Comal County Environmental Health OSSF Inspection Sheet

Permit of Authorization to Construct an On-Site Sewage Facility Permit Valid For One Year From Date Issued

ON-SITE SEWAGE FACILITY APPLICATION

We received planning materials for the referenced permit application on 02-07-2023 and found those planning materials to be deficient. In order to continue processing this permit, we need the following:

SITE PLAN & OSSF DESIGN

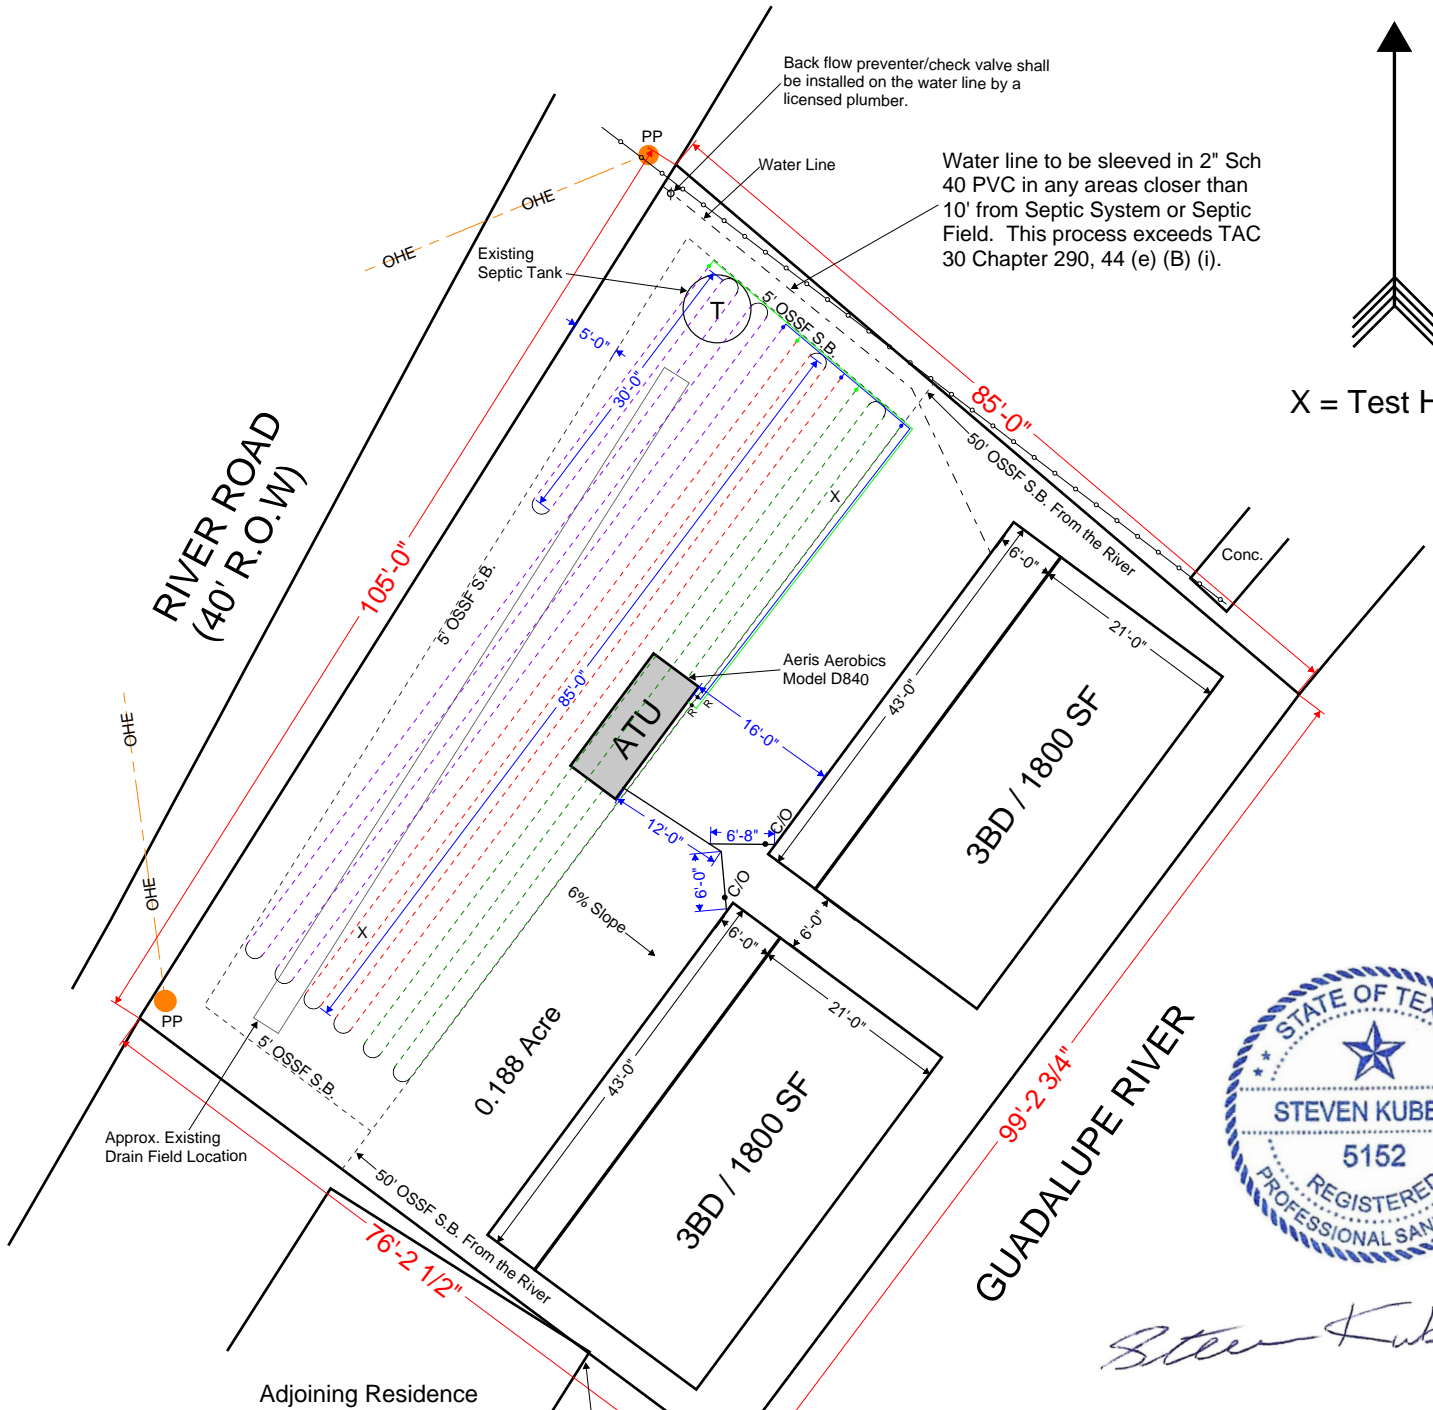
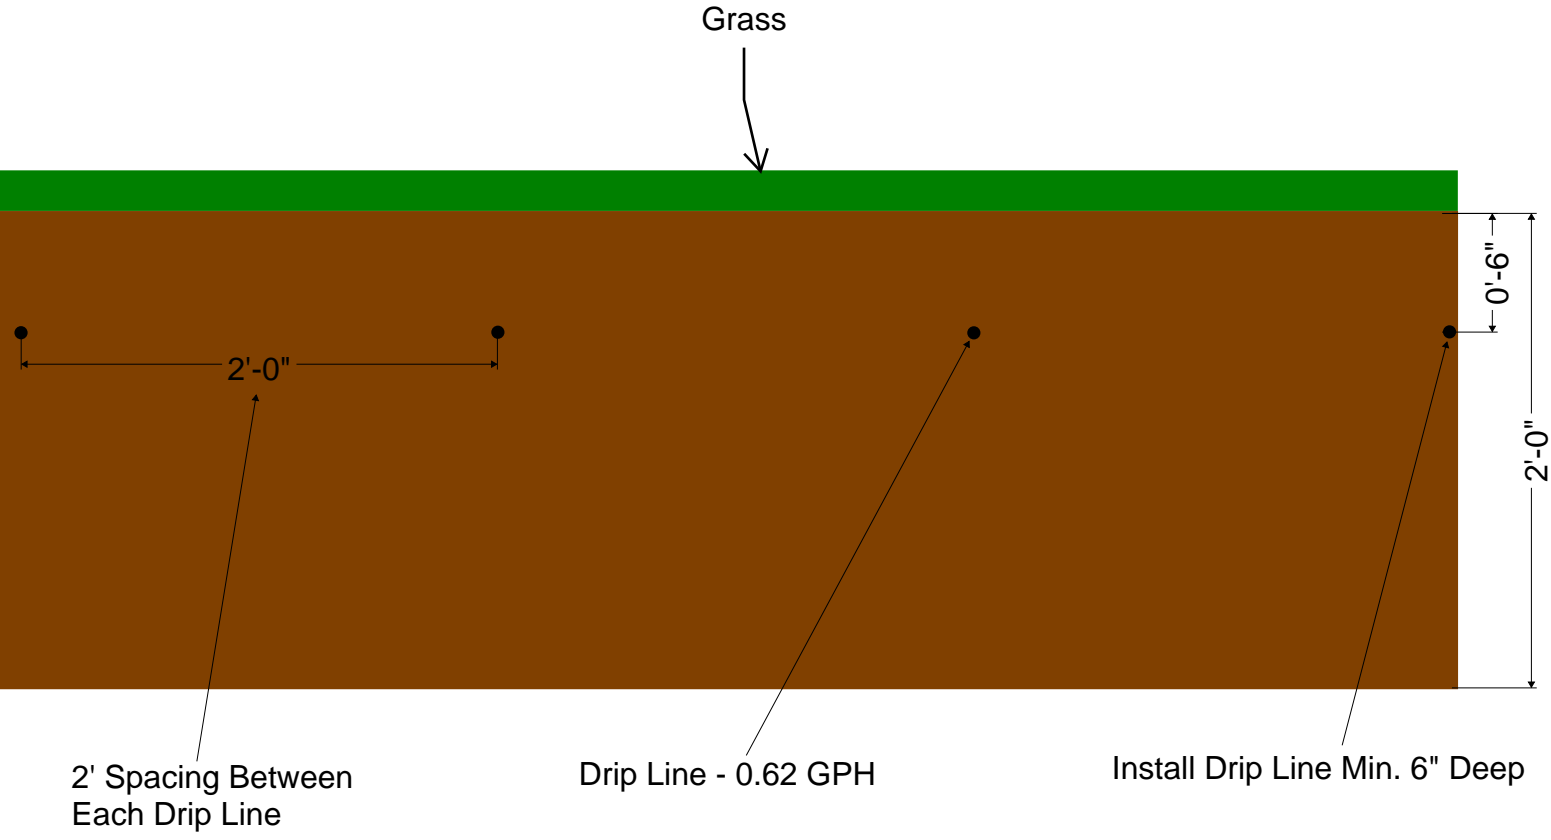
A variance, to the rules in TAC 285, is requested to reduce the 10' separation distance from the waterline to the drip field. To provide equivalent protection, the water line is to maintain a 2.5' minimum separation distance from the drip field. Also, the water line is to be sleeved in any area within 10' of the drip field/sewer pipe, and a licensed plumber is to install a back flow preventer/check valve on the water line, as shown.

- ✓ I am still waiting on a response from the subdivision coordinator for the plat showing tract 5A
 - a. I will reach out once they get back to me
- ✓ The separation distance from waterline to drip field needs to be in the form of a variance request to the rules in TAC 285
 - ✓ TAC 285.31(c)(2)(A)(B)(C)

Please see the attached 6790 River Rd. New Braunfels, Tx 78132 - Septic Design REVISED. The variance request for the waterline separation is within the attachment.
